PCB review DCRC Rev G

External Reviewers: Greg Deuerling and Neal Wilcer (sent their comments via email, not on the call)

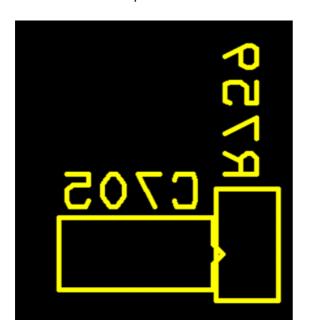
I see two via spacing errors U97 pins V7 & V8:

Checked -- this is OK, just some strangeness in how OrCAD calculates clearances on non-90 degree components. Clearances OK here.
